Subject: Duke Energy Carolinas, LLC.
William States Lee III Nuclear Station - Docket Nos. 52-018 and 52-019
AP1000 Combined License Application for the
William States Lee III Nuclear Station Units 1 and 2
Response to Request for Additional Information
(RAI No. 1473)
Ltr# WLG2008.12-28

Reference: Letter from Brian Hughes (NRC) to Peter Hastings (Duke Energy),
*Request For Additional Information Letter No. 044 Related To SRP
Section 02.05.04 – Stability of Subsurface Materials and Foundations
Application for the William States Lee III Units 1 and 2 Combined License
Application, dated October 29, 2008*

Lee Nuclear Station Response to Request for Additional Information (RAI)

Attachment 1 to RAI 02.05.04-002

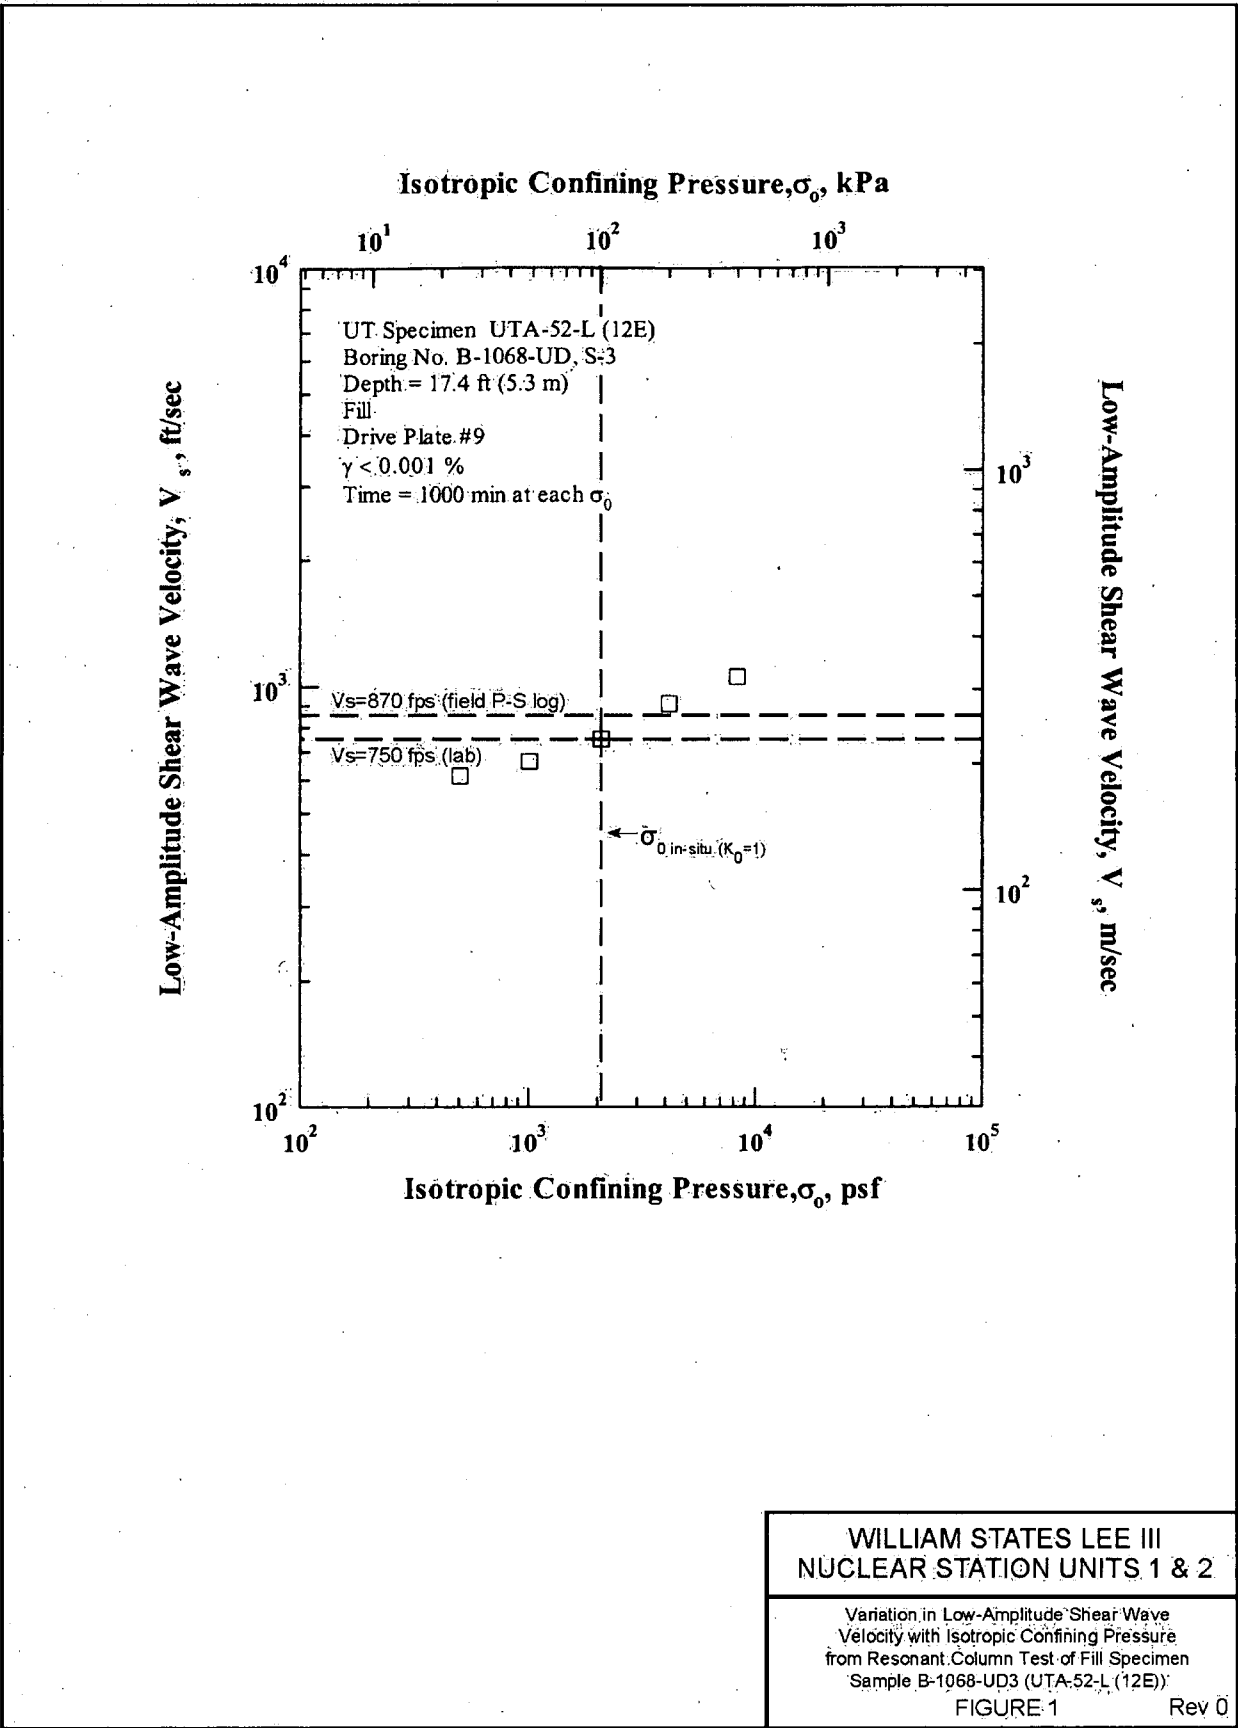
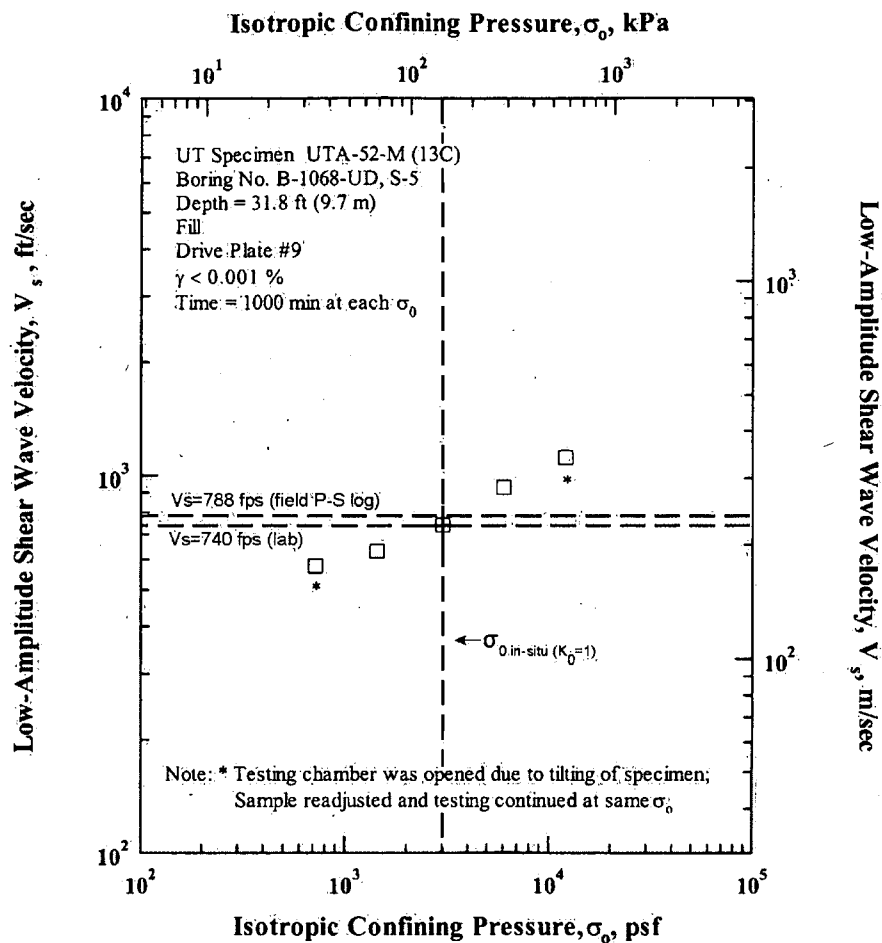
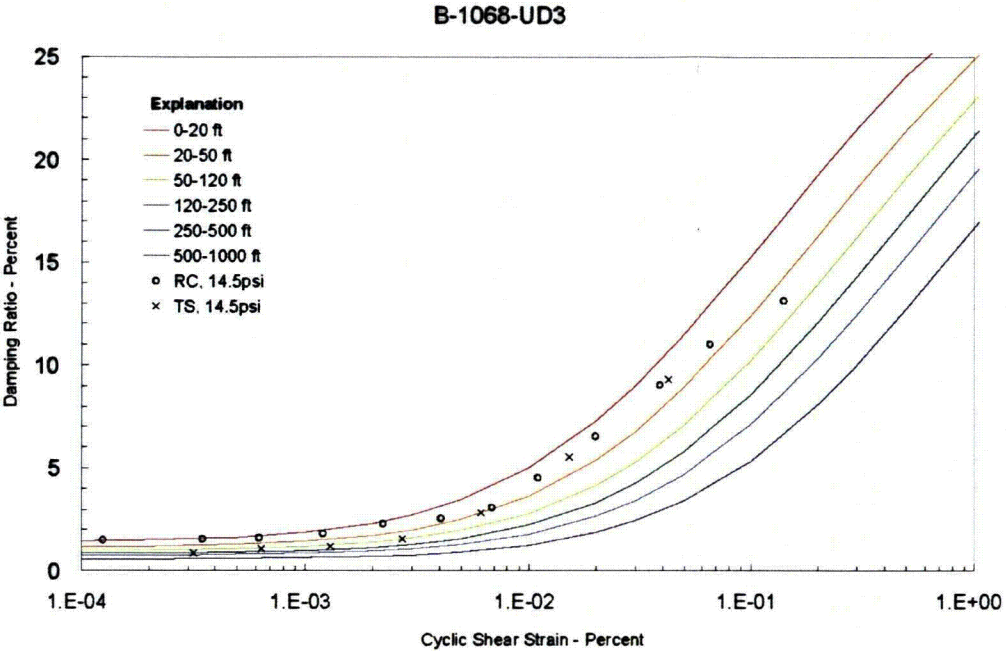
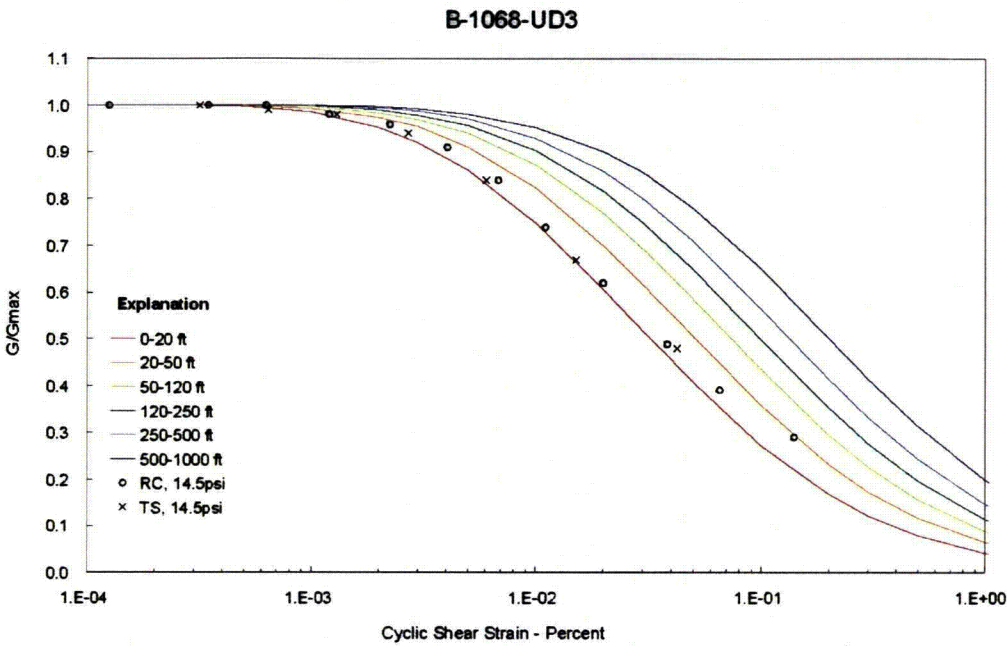
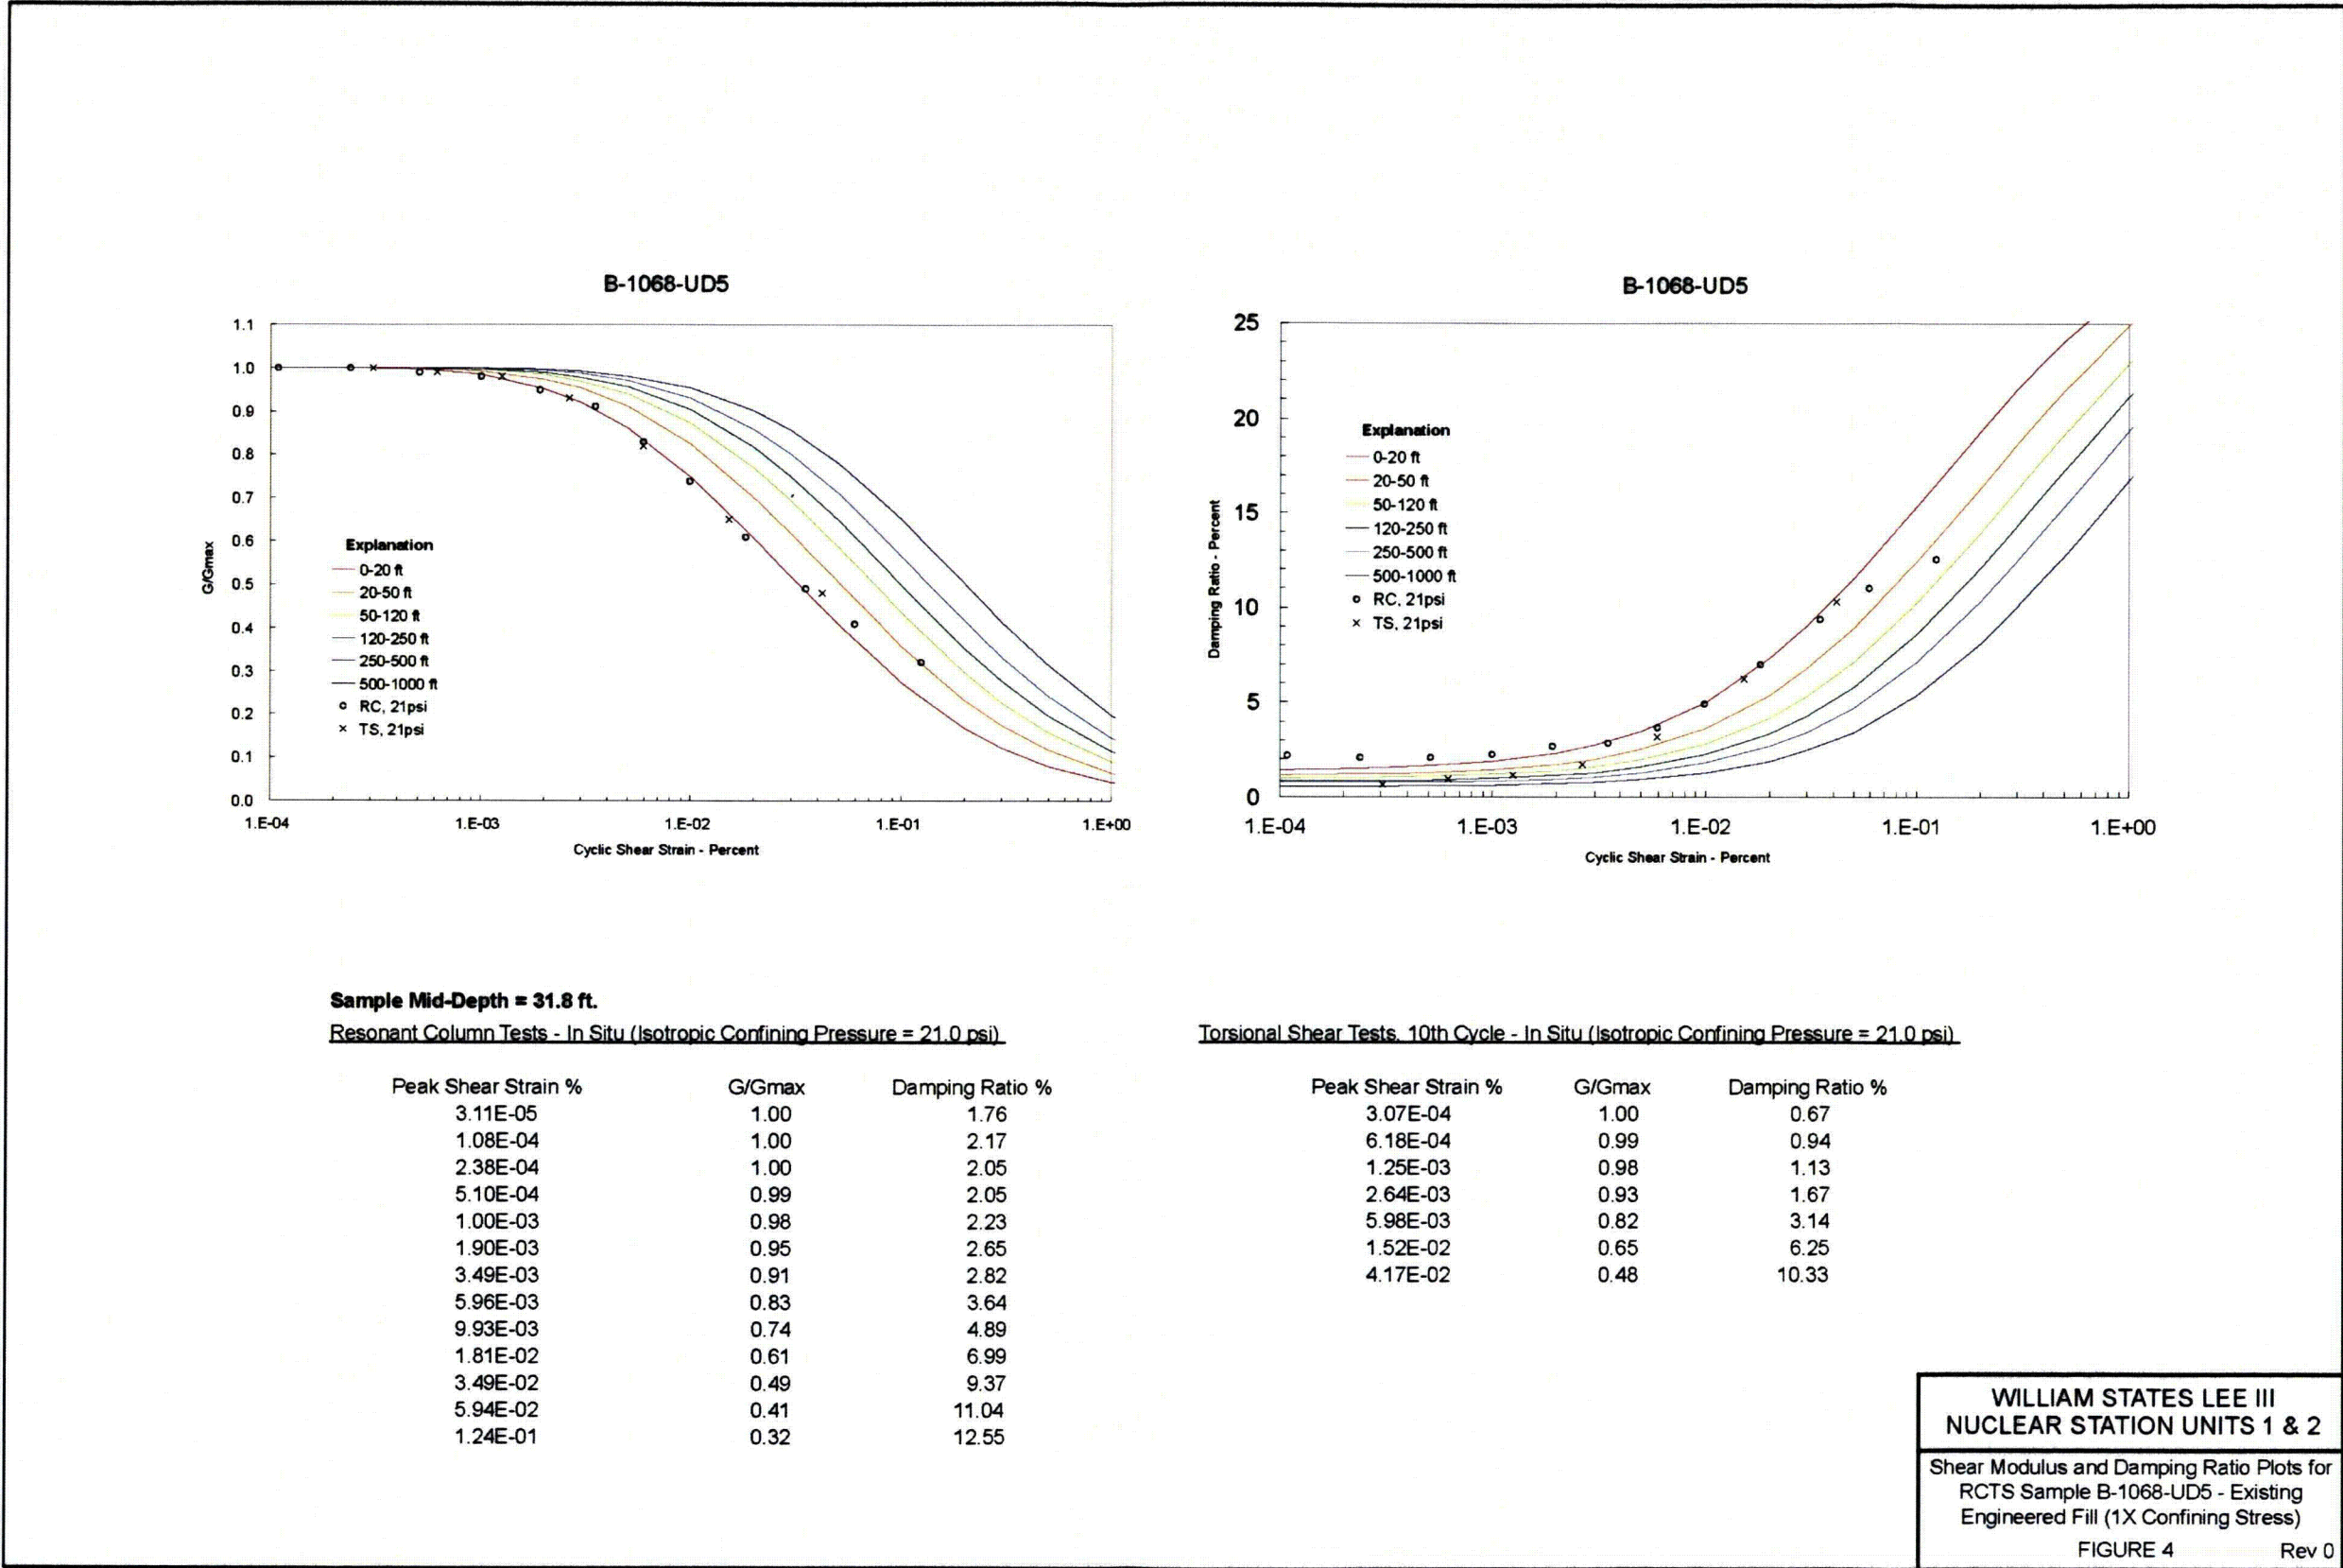
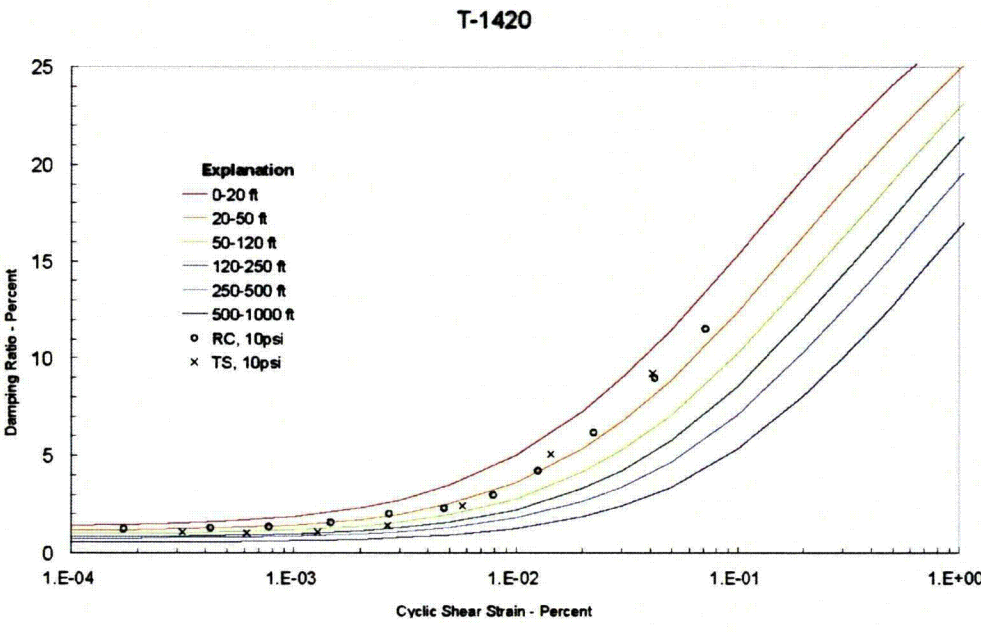
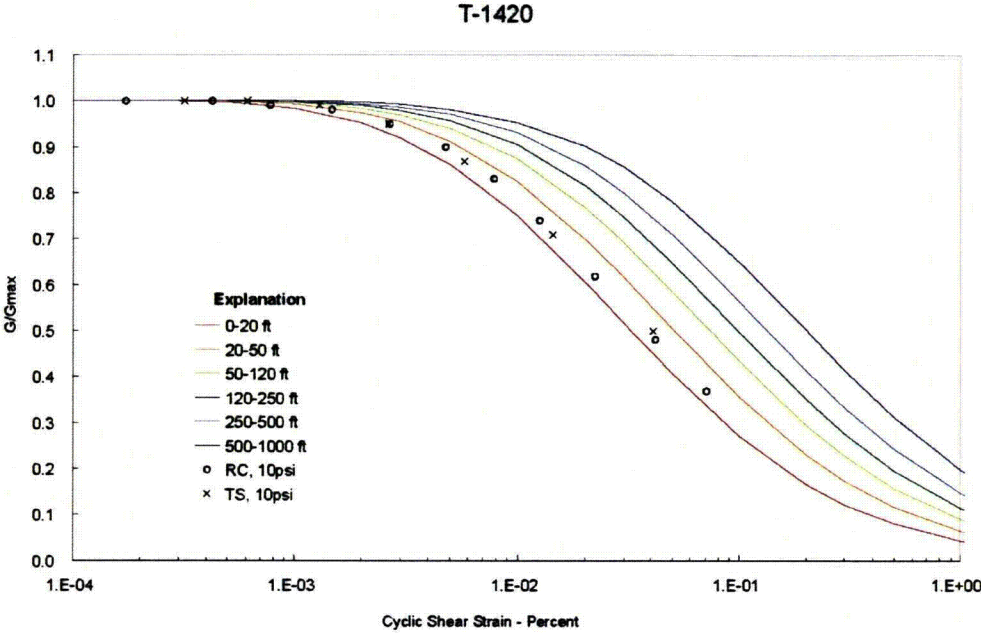
In FSAR Section 2.5.4.7, "Response of Soil and Rock to Dynamic Loading," Figures 2.5.4-253 2.5.4-254, you present the RCTS testing performed in conformance with the requirements of Regulatory Guide 1.138. There is variability in the RCTS test data over the range of testing pressures and the plotted test data lie outside beyond the limits of the two selected EPRI curves. Please justify how the selected curves represent the site-specific test data.

The RCTS lab testing was performed on a range of isotropic pressures to bracket estimates of in-situ confining pressure (K_0). The K_0 values used for sample testing were estimated values. The K_0 for compacted fill is estimated to be 0.9 (FSAR 2.5.4.10.3). The laboratory-measured small strain shear modulus shear wave velocity, G_{\max} (V_s), value from the RCTS tests should approximately agree with the field-measured in-situ V_s value at the corresponding depth if the K_0 assumption is approximately correct and if the effect of aging on the in-situ G_{\max} is relatively minor. The laboratory and in-situ V_s values were compared at small strain conditions to estimate if the RCTS tests at 1X estimated confining stress in-situ (σ_o) using $K_0 = 1$ appear to be representative of the in-situ measured V_s . The evaluation of the lab-measured V_s to field-measured V_s for the existing Group I engineered fill, samples, B-1068-UD, S-3 (Figure 1) and B-1068-UD, S-5, (Figure 2) show good correlation using the lab mean confining stress to represent the in-situ confining stress at K_0 equal to 1 (field V_s 750fps/lab V_s 870 fps) and (field V_s 740fps/lab V_s 788 fps), respectively. Therefore, the lab tests at 1X estimated in-situ confining stress are considered representative of the in-situ condition.

The factors considered in matching results of the RCTS tests with the appropriate EPRI curves included the material index properties, groundwater conditions, depth of sample, and potential thickness of fill. Because the soil types considered for backfill are generally low plasticity to nonplastic, the sand curves as presented in FSAR Figures 2.5.4-253 and 2.5.4-254 were selected. Figures 3 through 7 describe shear modulus and damping ratio plots for two Existing Group I Engineered Fill and three Remolded Samples at 1X in-situ confining stress, (σ_o estimated with K_o equal to 1). These plots justify the selection of the two EPRI curves, 0-20 feet and 20-50 feet, as described in FSAR Subsection 2.5.4.7.3. The selected curves span the observed range of dynamic properties and are used to evaluate site-specific epistemic variability of proposed Group I engineered fill. For site response analyses (Reference 1) of non-Category I structures founded on or over compacted Group I engineered fill over continuous rock, or Group I engineered fill over saprolite soils overlying partially weathered / continuous rock, the process used in evaluating epistemic variability adequately accounts for the minor differences in the test curves and the two EPRI curves. One remolded sample, T-1422, Figure 7, is somewhat inconsistent with the EPRI curve but this is not considered significant since this is only one out of the five RCTS tests representing the future Group I engineered backfill.
